## **Attachment 4**

### **Proposed Tech Spec Change Retyped**

Figure B 3.7.9-1  
CREATS

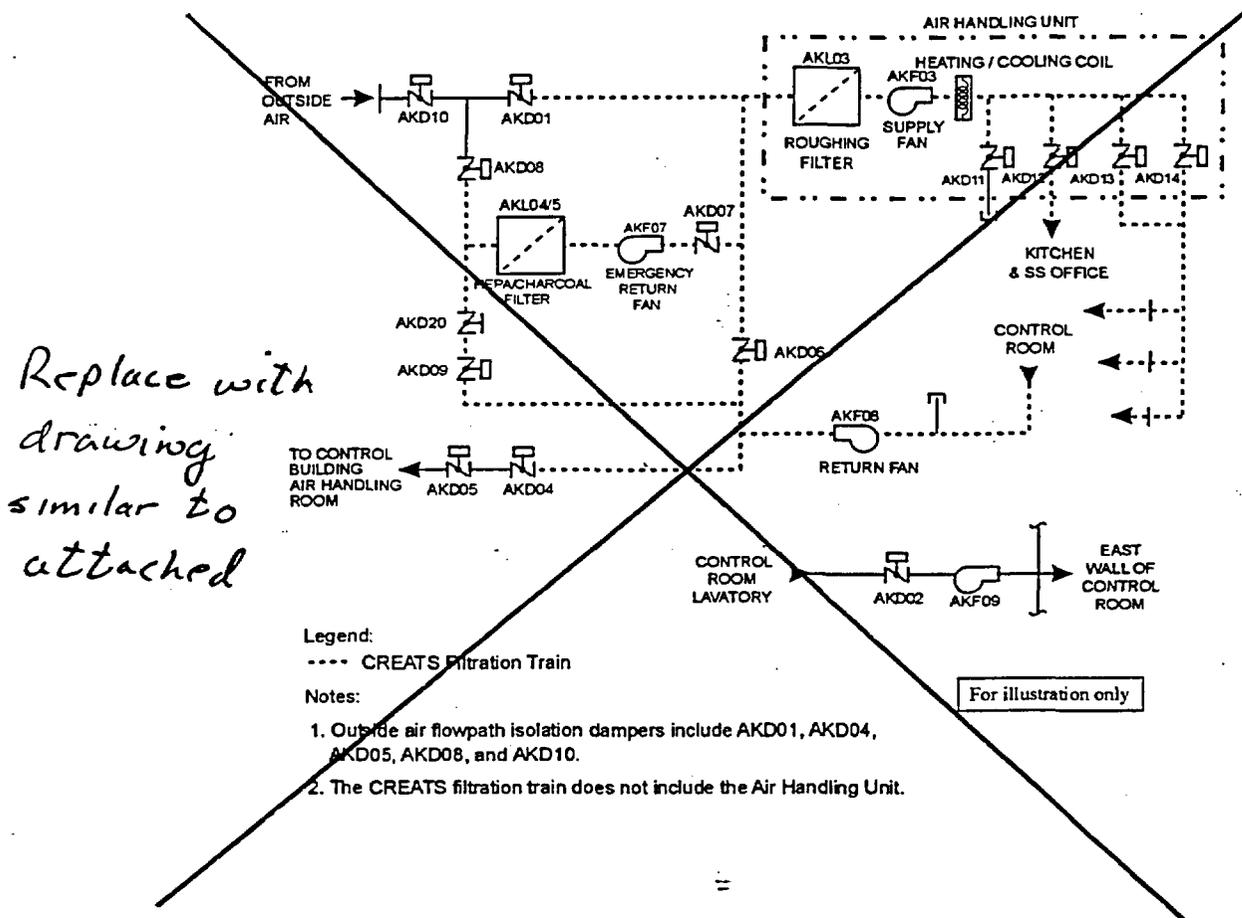
*Replace with  
attached*

Replace with drawing similar to attached
